No. 0692-258  
ATA Code 71-60

**SUBJECT:** POWER PLANT - INDUCTION SYSTEM - INSTALLATION OF A CLAMP ON THE INDUCTION AIR HOSE

**EFFECTIVITY:** BEEHCRAFT B19, serials MB-481 through MB-520;  
B19 Sport 150, serials MB-521 through MB-730, MB-733 through MB-736, MB-741, MB-743, MB-749, MB-750 and MB-753.

Figure 1  
(Looking Aft)

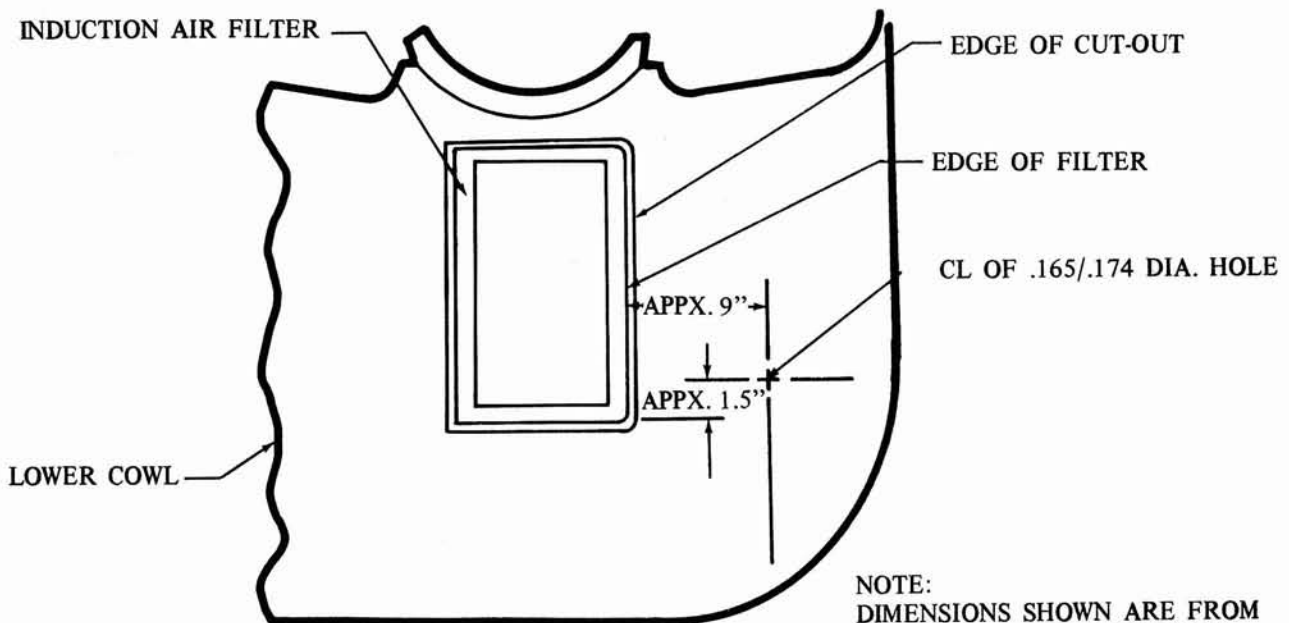
1. Remove the upper engine cowl.
2. Inspect the existing induction air duct to determine that its P/N is 115167EXX121063 (26.5 inches long) and that it is in good condition. If either of the above conditions is not present the duct should be replaced with a new 115167EXX121063 induction air duct.
3. Drill a .165/.174-inch diameter hole through the lower engine cowl at a location 9 inches to the right of the edge of the induction air filter and 1.5 inches above the bottom edge of the induction air filter when viewed from the forward side looking aft. Figure 1 shows the location of this hole.
4. Secure the 115167EXX121063 induction air duct to the lower engine cowl using an MS21919DG48 clamp, AN526-832R10 screw and an AN364-832 nut. The head of the screw is to be on the outside of the cowl. This installation is shown in figure 2.

NOTE:  
DIMENSIONS SHOWN ARE FROM  
EDGE OF FILTER, NOT FROM  
CUT-OUT.

Figure 2

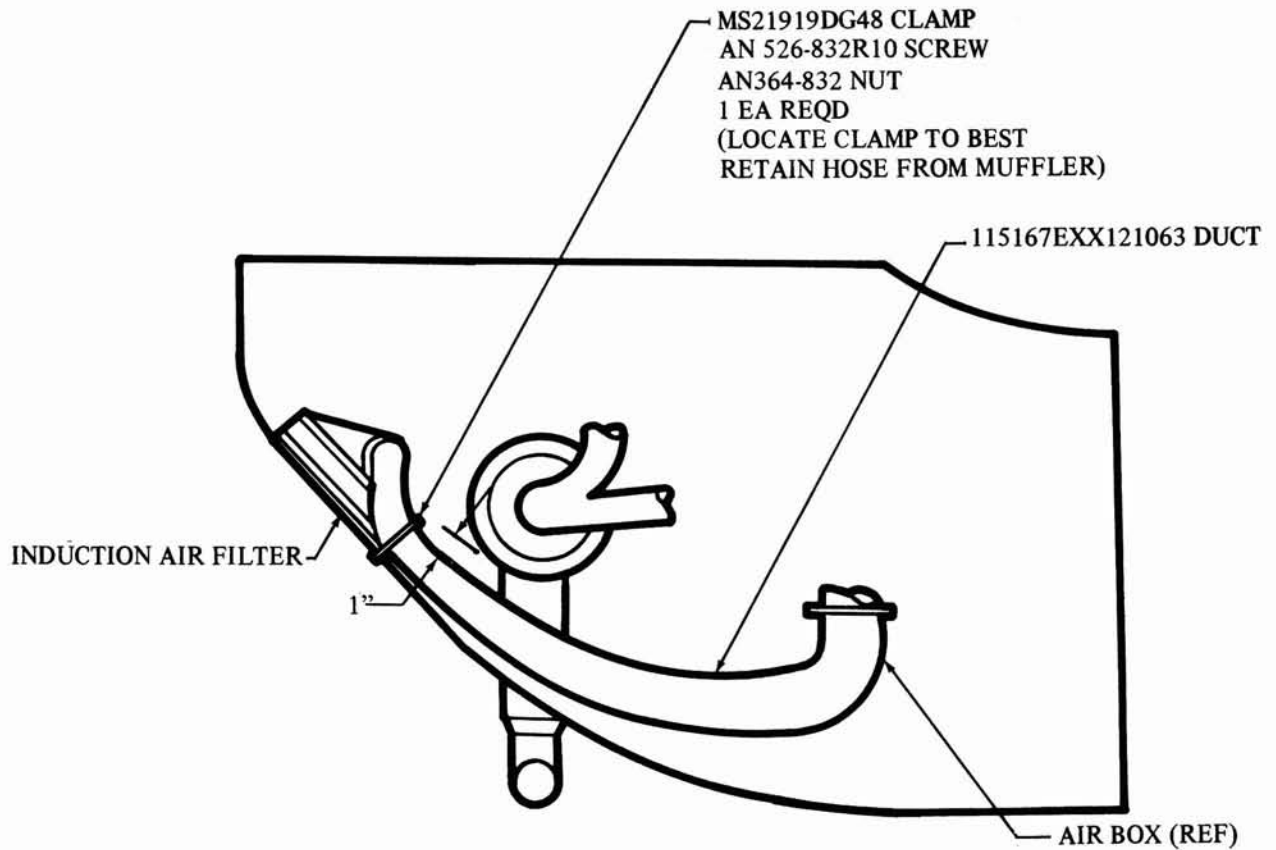
5. After completion of this installation there should be a minimum of one inch distance between the exhaust muffler and the induction air hose.
6. Replace the upper engine cowl.
